STAFF RECOMMENDATION

NCPC File No. 6117

COLUMBUS CIRCLE AND COLUMBUS PLAZA IMPROVEMENTS

April 30, 2009

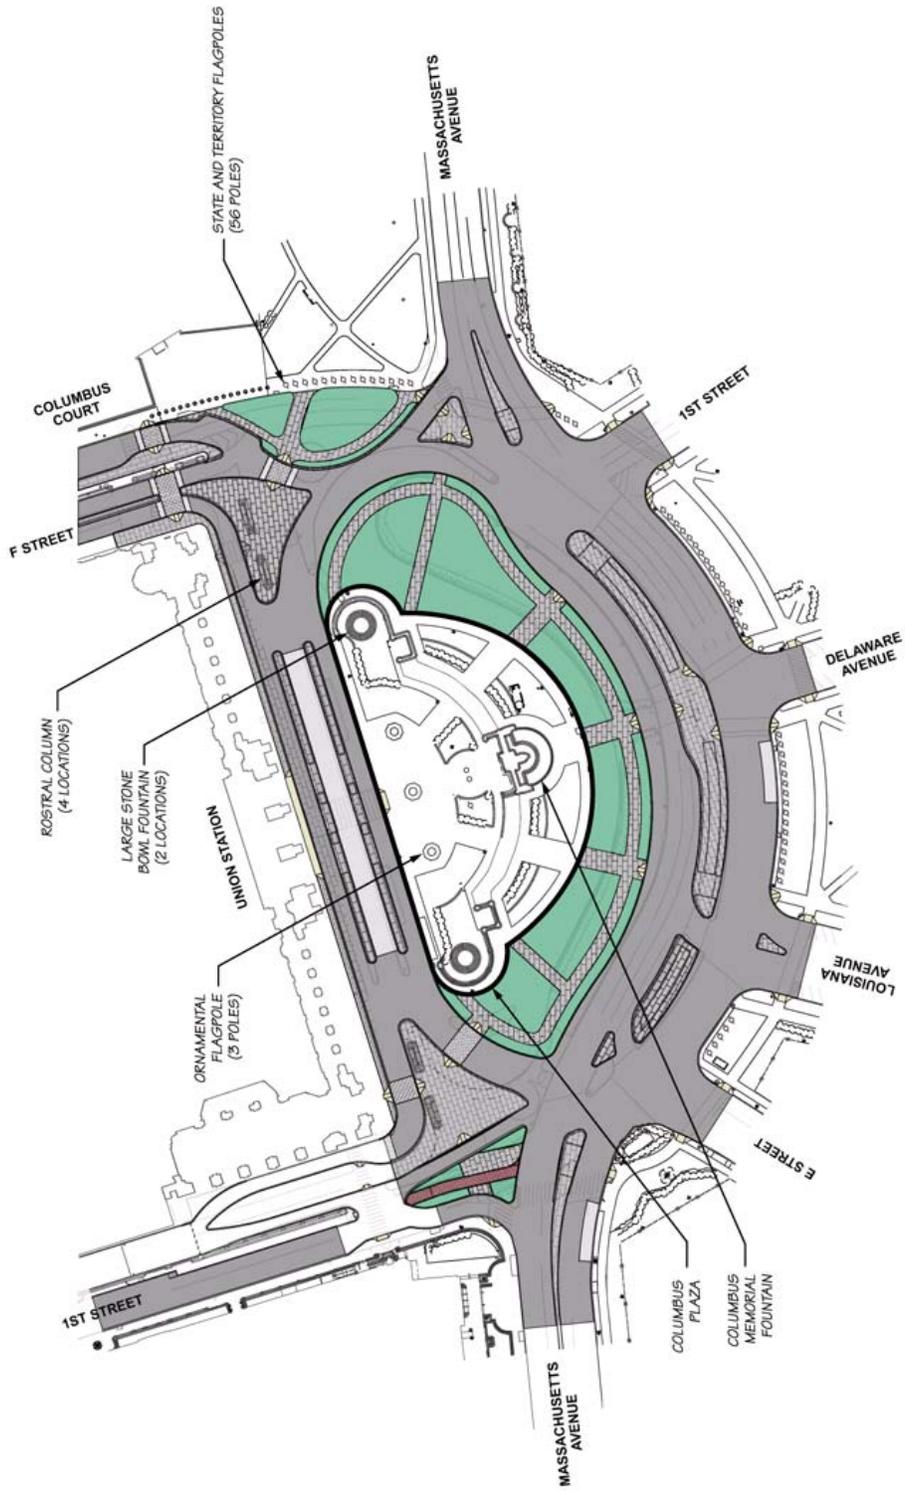
The photograph below, looking southwest, shows the existing conditions, including the interior access road within the plaza that will be removed and replaced with grass lawn and pedestrian sidewalks, as indicated in the proposed site development plan on the following page. New or lengthened or repositioned traffic islands have been designed to improve pedestrian safety.
